RS-14-213

Quad Cities Nuclear Power Station, Units 1 and 2
Renewed Facility Operating License Nos. DPR-29 and DPR-30
NRC Docket Nos. 50-254 and 50-265

Subject: Third Six-Month Status Report in Response to March 12, 2012 Commission Order
Modifying Licenses with Regard to Requirements for Mitigation Strategies for Beyond-
Design-Basis External Events (Order Number EA-12-049)

**Third Six-Month Status Report for the Implementation of Order EA-12-049, Order
Modifying Licenses with Regard to Requirements for Mitigation Strategies for Beyond-
Design-Basis External Events**

MAAP Calculation of RPV Pressure During RPV Depressurization

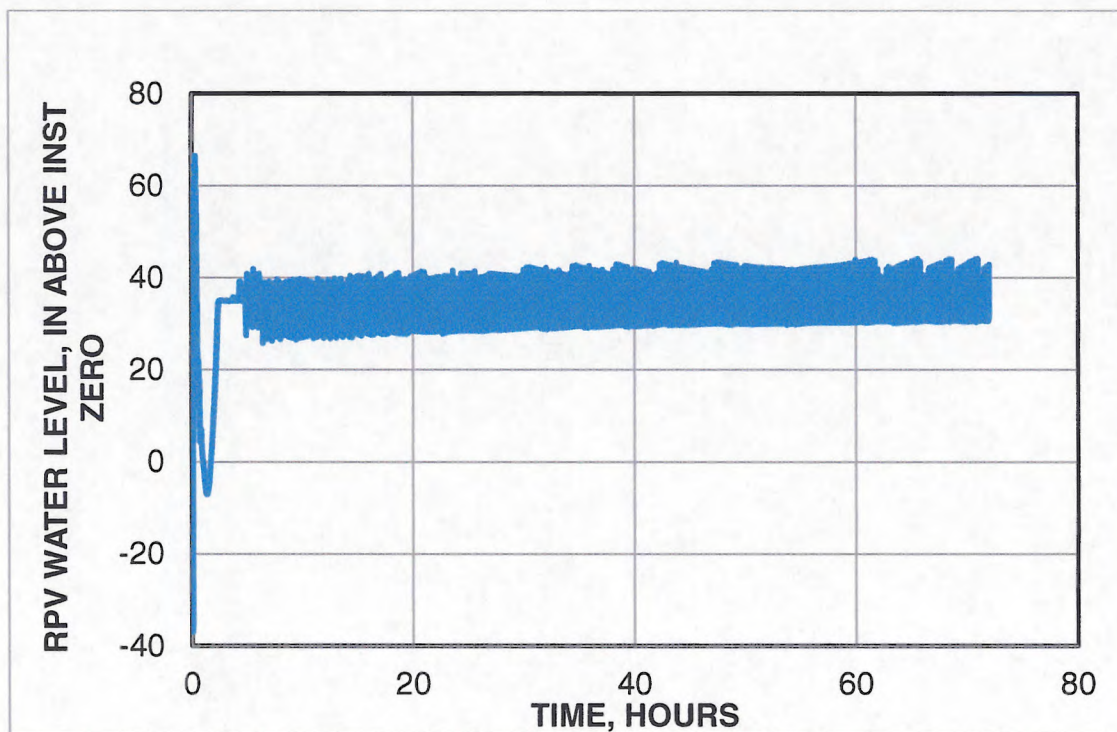
3.2.1.1.B The collapsed level must remain above Top of Active Fuel (TAF) and the cool down rate must be within technical specification limits in the MAAP4 analysis.

The Quad Cities Integrated Plan states that the operators would commence a cooldown of the RPV after the RPV water level reaches +40" at a rate of 80°F/hr which is within the technical specifications limit of 100°F/hr. The following plot of the RPV pressure from the MAAP analysis uses a cooldown initiation setpoint of +40" water level in the RPV.

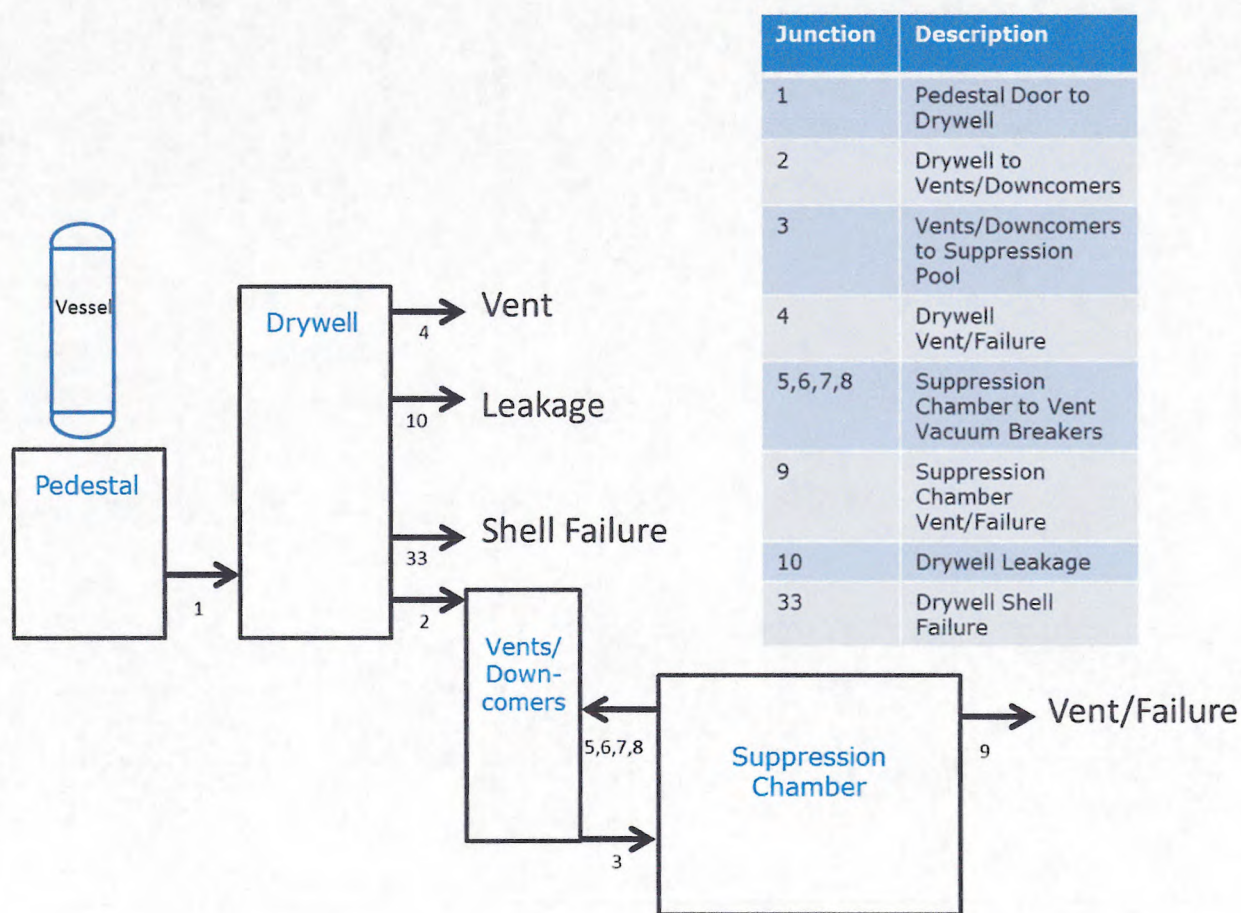
3.2.1.1.D In using MAAP4, the licensee must identify and justify the subset of key modeling parameters cited from Tables 4-1 through 4-6 of the "MAAP4 Application Guidance, Desktop Reference for Using MAAP4 Software, Revision 2" (Electric Power Research Institute Report 1 020236). *This should include response at a plant-specific level regarding specific coding options and parameter choices for key models that would be expected to substantially affect the ELAP analysis performed for that licensee's plant. Although some suggested key phenomena are identified below, other parameters considered important in the simulation of the ELAP event by the vendor / licensee should also be included.*

- a. Nodalization
- b. General two-phase flow modeling
- c. Modeling of heat transfer and losses
- d. Choked flow
- e. Vent line pressure losses
- f. Decay heat (fission products / actinides / etc.)

- a. The reactor vessel nodalization is fixed by the MAAP code and cannot be altered by the user, with the exception of the detailed core nodalization. The Quad Cities MAAP 4.0.5 parameter file divides the core region into 5 equal volume radial regions (See NCHAN) and 13 axial regions (See NAXNOD). The axial nodalization represents 25 equal-sized fueled nodes (see NROWS), 1 unfueled node at the top (see NNFT), and 2 unfueled nodes at the bottom (see NNFB). The figure below, taken from the MAAP Users Manual, illustrates the vessel nodalization scheme.

Containment nodalization is defined by the user. The standard nodalization scheme is used in the Quad Cities MAAP 4.0.5 parameter file and represents the following individual compartments:

1. Reactor pedestal region
2. Drywell
3. Drywell vents to torus
4. Torus (Wetwell)
